SEAS DEADLINE 6 RESPONSE to APPLICANTS's SUBMISSIONS
SINCE DEADLINE 5, ISH3, Action Points and ExQ3
LANDSCAPE & VISUAL and CULTURAL HERITAGE

PINS Ref: EN020026
DEADLINE 6: APRIL 13, 2026

EN020026 SEA LINK DCO – DL6: RESPONSE BY NICHOLAS BRIDGES

ZTV ANALYSIS – IP ref FA62B0DA

Figure 1. EN010077-001489-6.2.29.7 EAIN ES Figure 29.7 Onshore Substation ZTV (with landscape character)

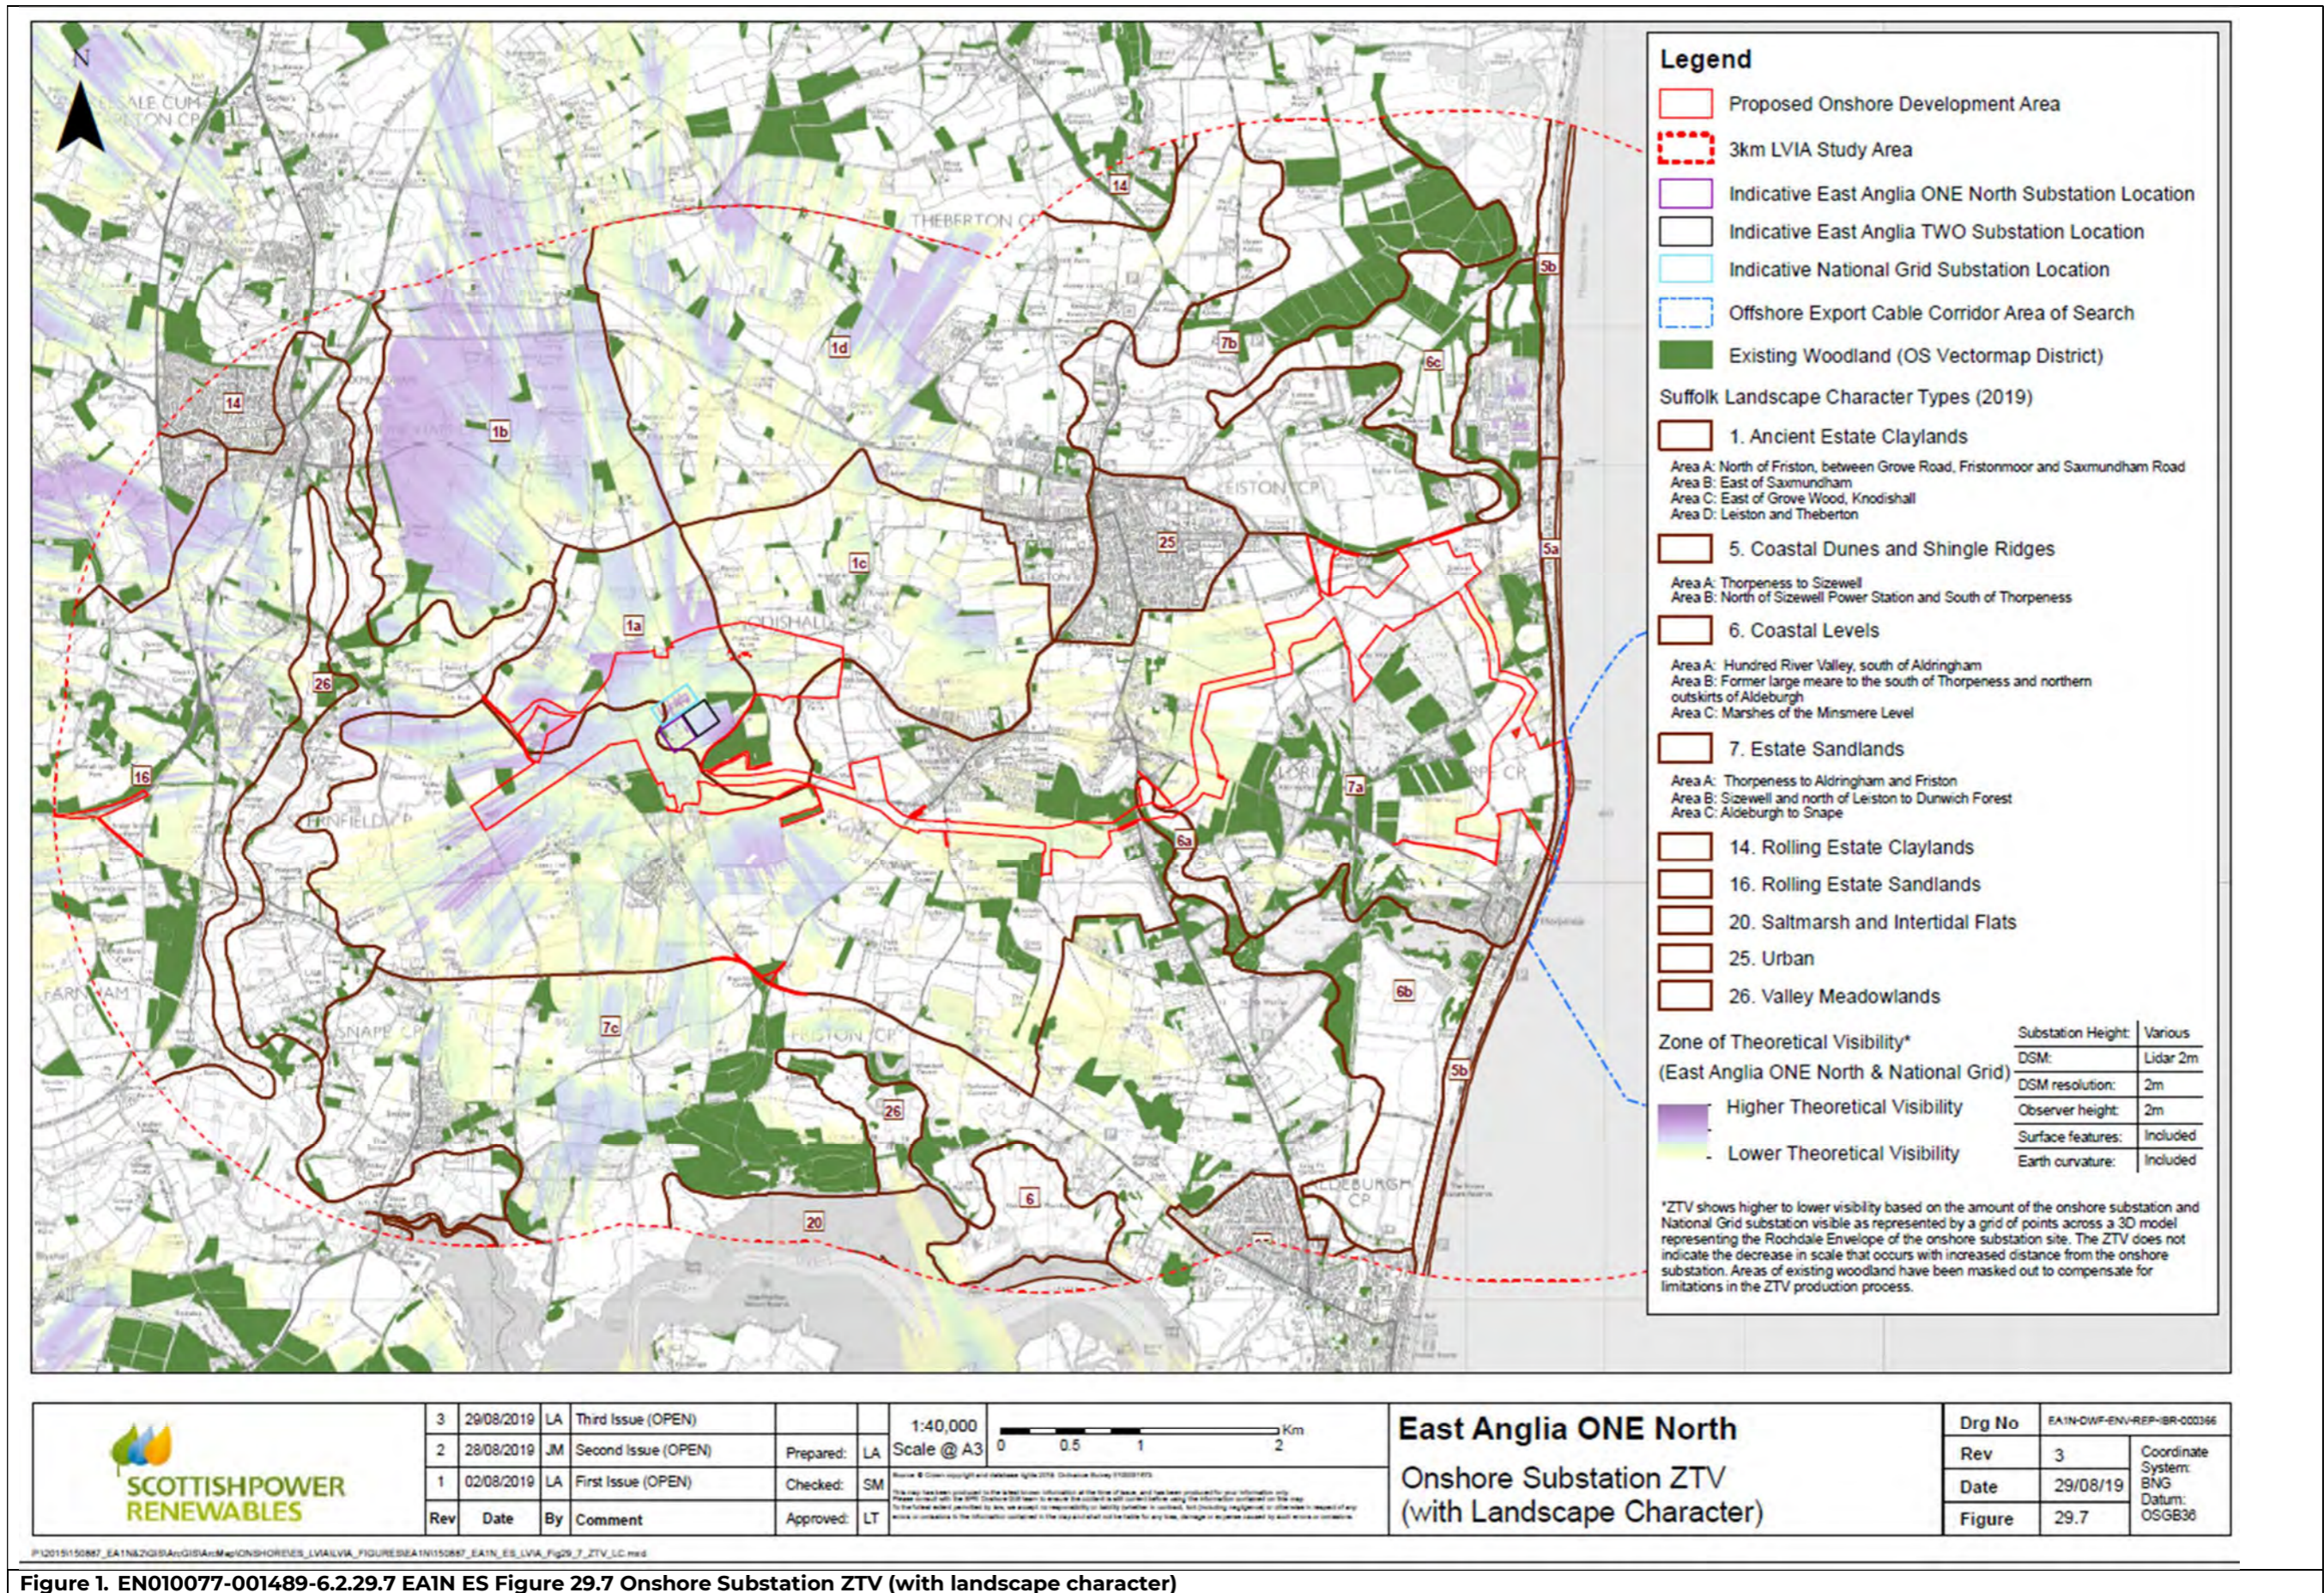
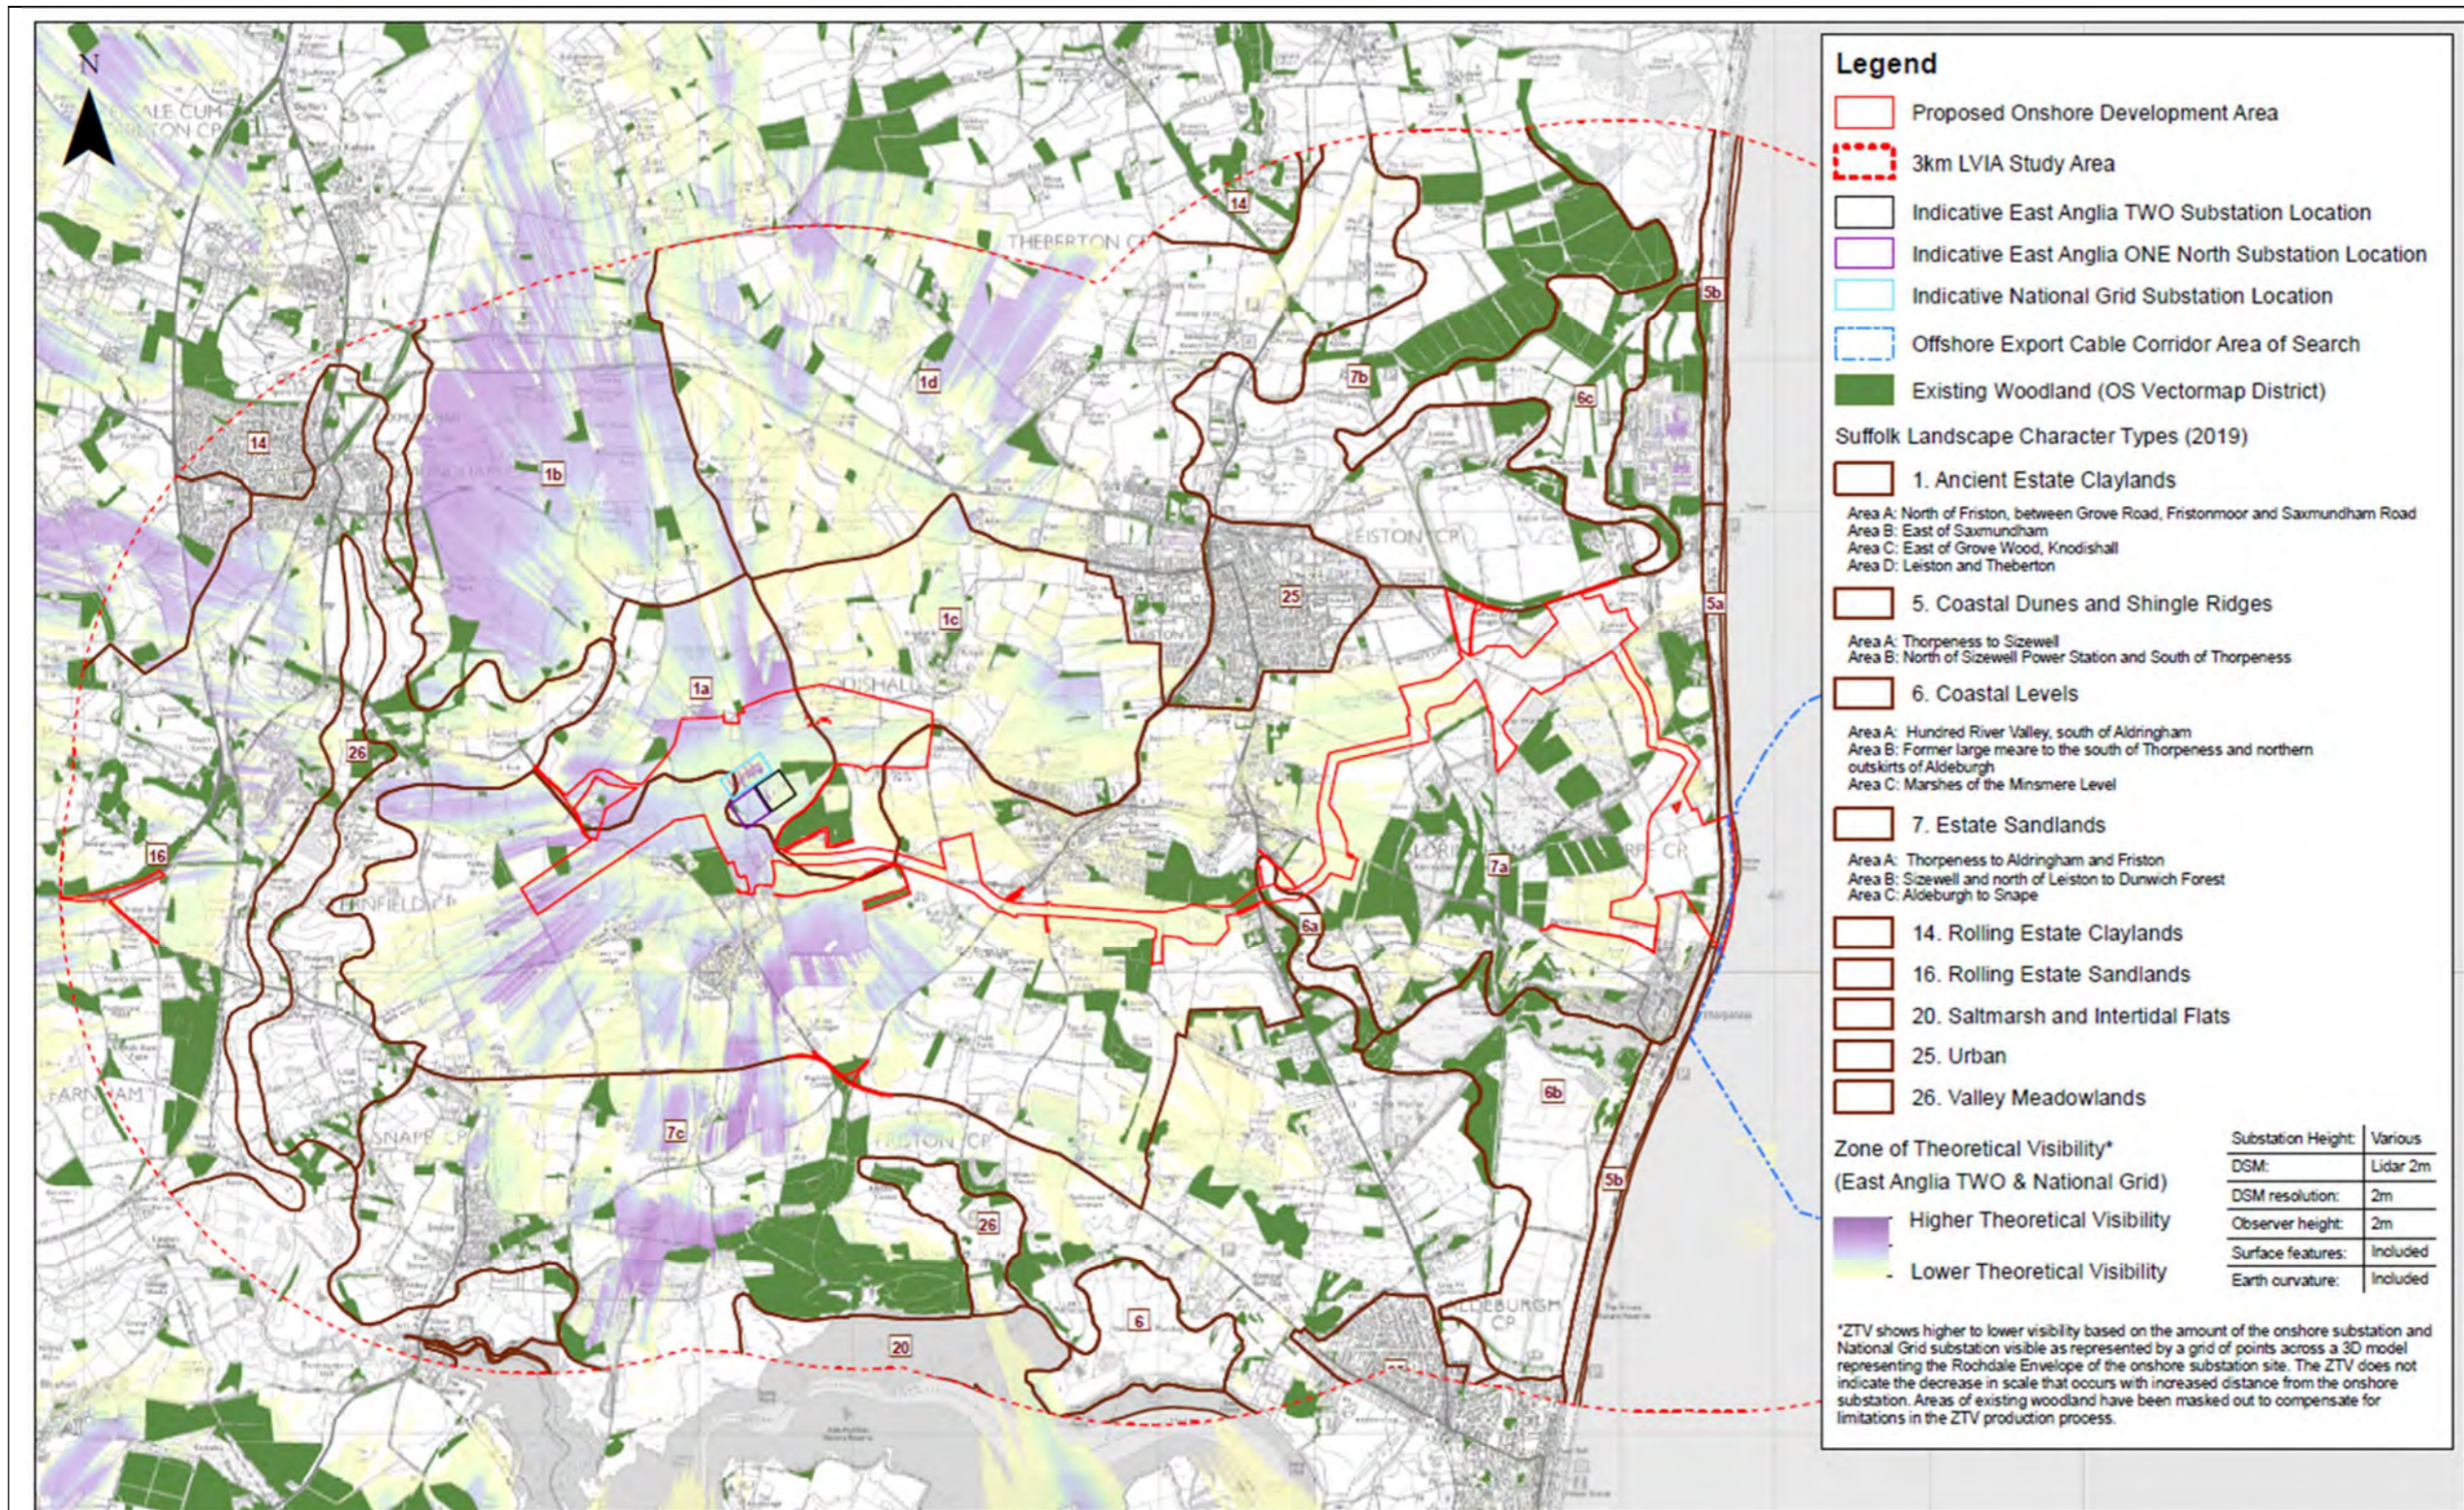
2.9. The ZTVs of the two Friston projects and Sea Link's PEIR have a similar pattern of visibility around their projects (see **Figures 1 to 11** below). Sea Link includes the National Grid substation at Friston which each of EA1N and EA2 also included. All Projects were modelled using OS contours, woodland and buildings at a generic height. Observer heights were a little higher for EA1N and EA2. The two Friston substations used the same parameter model as Sea Link.

2.17. The applicant does not seem aware of the EA1N and EA2 ZTV plans (**Figures 1, 2 and 3** below) which show that those developments would be visible. Nor the Sea Link PEIR likewise. Visibility from the top of the church tower is not relevant as the public have no access nor is it important as a private viewing point, unlike the Martello Tower for which this use was its primary function.
